LATE REPRESENTATIONS

Committee PLANNING COMMITTEE

Date and Time of Meeting WEDNESDAY, 13 FEBRUARY 2019, 10.30 AM

LATE REPRESENTATIONS SCHEDULE
PLANNING COMMITTEE –13TH FEBRUARY 2019

rear elevation

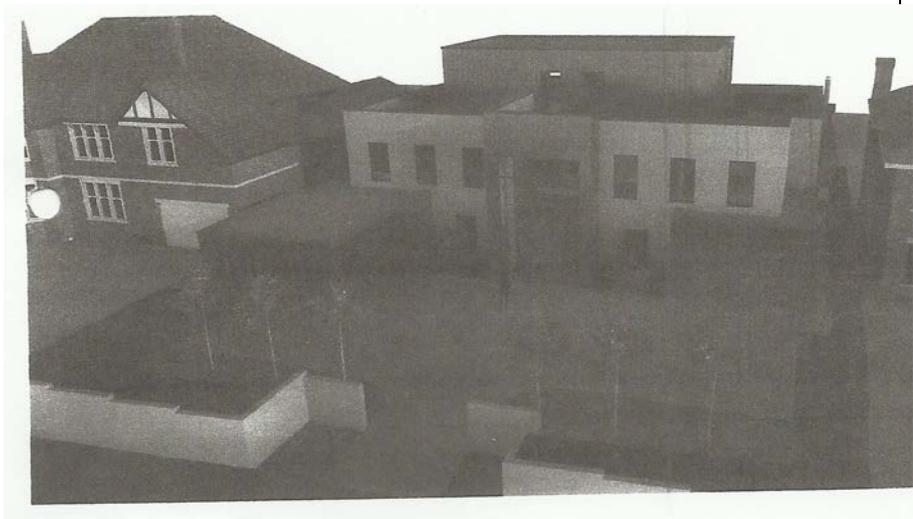
PAGE NO. 47	APPLICATION NO. 18/02698/MNR
ADDRESS:	19 LLANDENNIS AVENUE, CYNCOED
FROM:	Mr Winston Roddick CB QC
SUMMARY:	<p>1. Thank you for attending and facilitating the site visit to 19 Llandennis Avenue on the 4th February. It was appreciated by all the residents who were present.</p> <p>2. You will recall that I asked at the site visit if during my presentation on behalf of the petitioners at the meeting of the planning committee on Wednesday 13 Feb the developers images of what the proposed development would look like three- dimensionally could be exhibited on the screen. I forward scanned copies of those images. I hope they are satisfactory. I made a similar request in relation to page 5 of the relevant SPG which I attach for convenience. You will</p>

recall that at the meeting on the 23rd January, councillors Molick and Kelloway sought to refer to both the images and the planning policy in the course of their address to the committee but were told they could not by the chair of the meeting. The images and page 5 are central to the objector's case.

Point 2 – Page 5 of the Infill Sites SPG has been added to the Planning Officers PowerPoint presentation to committee and has been considered in the officer report. With regard to the 3D images of the proposed dwelling, these have not been formally submitted by the applicant as part of the planning application. The images are included in this late representation in order for the Committee Members to view ahead of the meeting as requested. Members will be given a full explanation of the nature of the proposal in the powerpoint presentation and are familiar with understanding plans and sections.

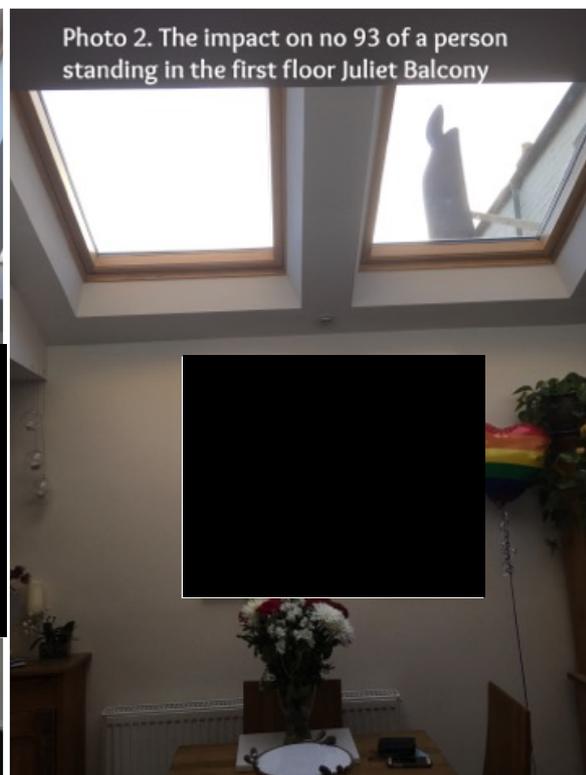
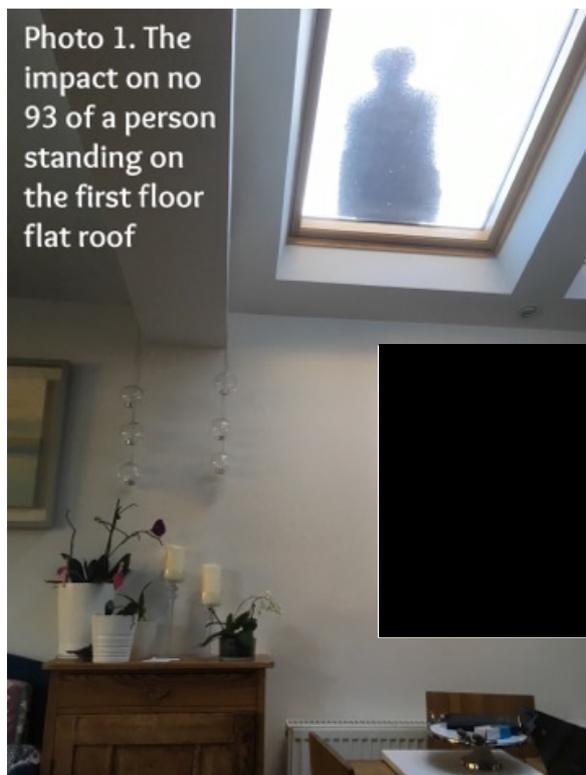
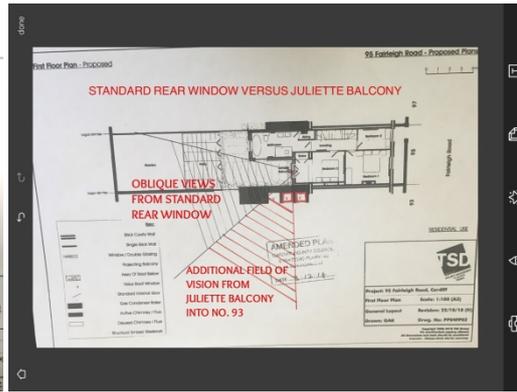
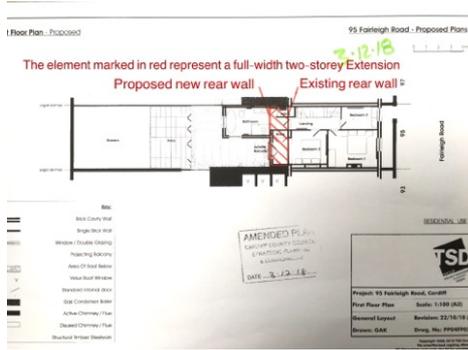
The dormer extension comprises 2 single Juliet balconies and a further two windows. (see elevation)

The report fails to mention that even under Development Permitted the box dormer should comply with point 7.82 of the SPG which requires the "the roof of the dormer should not extend to, or beyond the external wall of the existing roof" This box-dormer is full-width.

The proposed box dormer is full-width and therefore does NOT comply with the 7.82 of the SPG.

<p>Wales”</p> <p>We would like to request that the Case Officer uses the 45 degree Rule calculation to evaluate the loss of light.</p> <p>The following 4 pictures have been attached to this email and are to be included in this late representation.</p> <ol style="list-style-type: none"> 1. Full-width, two-storey element 2. The full-width box dormer as proposed is exactly the type that the SPG deems “excessively scaled” and “over-dominant” 3. The impact to 93 of someone standing on the flat roof. 4. The impact to 93 of someone standing in the first floor Juliet Balcony.
<p>REMARKS:</p>	<ol style="list-style-type: none"> 1. The report states that Fairleigh Road is characterised by traditional two storey terraced properties most of which with the exception of No’s 95 and 97 already have two storey rear annexes. The report also notes that two storey and single storey extensions have been constructed within the terrace at No’s 99, 101, 103 and 105 Fairleigh Road. These details were considered pertinent to the application and provided members with some local context. 2. The plans confirm that a two storey flat roof extension will project approximately 1.5m from the existing rear wall of the dwelling and that a single storey extension will infill the remainder of the space within the side return and will measure 6.8m long. 3. The submitted plans confirm that the dormer will be set down from the ridge, setup from the rear wall and set in from the sides of the dwelling house in line with the advice contained in paragraph 7.80 of the Residential Extensions and Alterations SPG. 4. An assessment of daylight using the 45 degree rule confirmed that the proposal would not result in an unacceptable loss of light into the kitchen/dining room of No 93 Fairleigh Road. 5. The neighbours diagram which estimates the angled views from the Juliette balcony is noted. <p>Please note that attachments were included with the late representations which will be available to view by the Committee Members.</p>
